REMARKS

PROPOSED AMENDMENT TO THE DRAWINGS

FIGURE 1

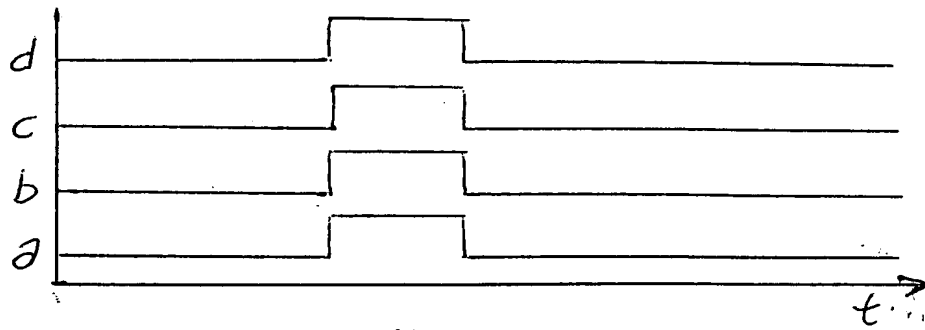
The drawings were also objected to for not illustrating the discharging of the several energy devices into a single spark generating device "at substantially the same time," citing claims 74, 97 and 98. Original Figures 1 and 3 illustrate four output circuits 40a-40d and 340a - 340d, respectively, connected to a single sparking device 50 and 350, respectively. Proposed Fig. 3a is a timing diagram illustrating discharge pulses from each of the output circuits 340a - 340d of Fig. 3 such that the pulses are delivered to the sparking device 350 "at substantially the same time." The timing overlap of the energy pulses to the devices 50 and 350 in Figs. 1 and 3, respectively, is described in detail in the original specification at, for example, page 20, lines 5-11 and page 29, lines 18-23 and in at least original claim 70.

In the Office action, the drawings are objected to under § 37 C.F.R. 1.83(a) for not showing every feature of the invention specified in the claims. The Office action specifically identifies language in claims 74, 90, 97 and 98. The Office action requires corrected drawings filed in accordance with Rule 121(d). Attached hereto is a proposed amendment to the drawings adding Figures 1A and 3A to sheets 1 and 3, respectively, of the original drawings. Pursuant to Rule 121 (d), replacements for sheets 1 and 3 are also attached.

FIGURE 3A

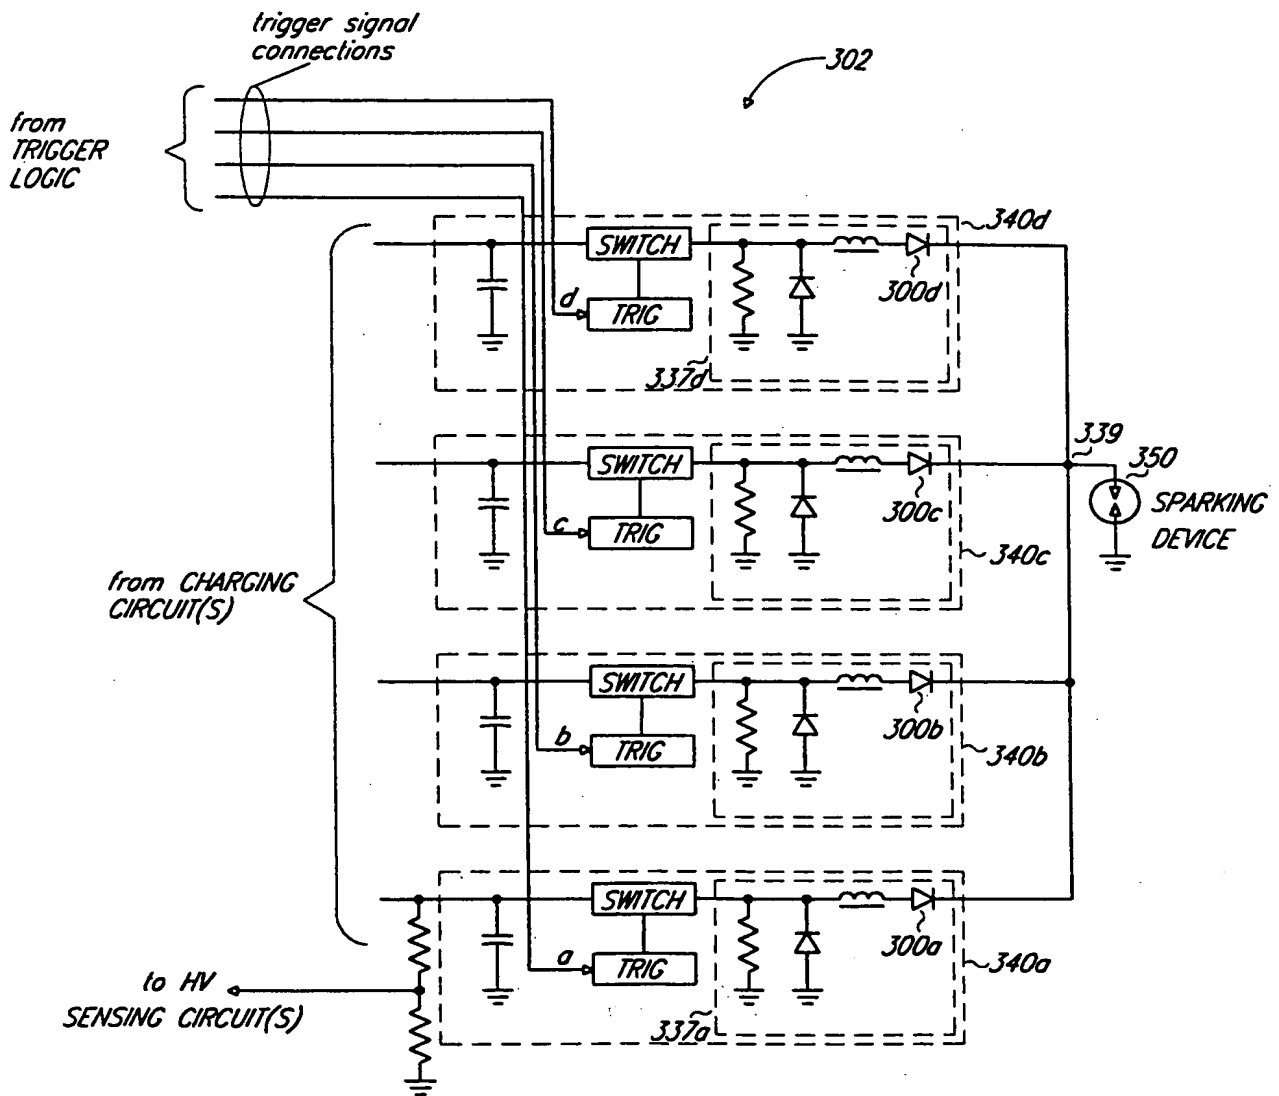
This amendment includes a proposed amendment to the drawings to illustrate the plume shape of a spark as described in the specification at various pages, including for example page 29, starting at line 6 to page 30 at line 4. The drawings were objected to for not illustrating the plume shape as recited in claim 90. Proposed Fig. 1A is a highly schematic representation of the plume shape of a spark event. Although the shape is illustrated as a simple circle, those skilled in the art of ignition systems will appreciate that the circle is not an actual shape.
